Specification change of Measuring Display Unit Breakers

We would like to inform that we will change the specification of Measuring Display Unit Breakers.

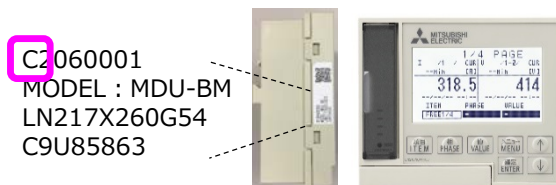
5. New / Old product discrimination method

Whether to support "MODBUS terminal connection confirmation" of EcoWebServer III can be confirmed on the label on the side of the product.

Before	After
B	C
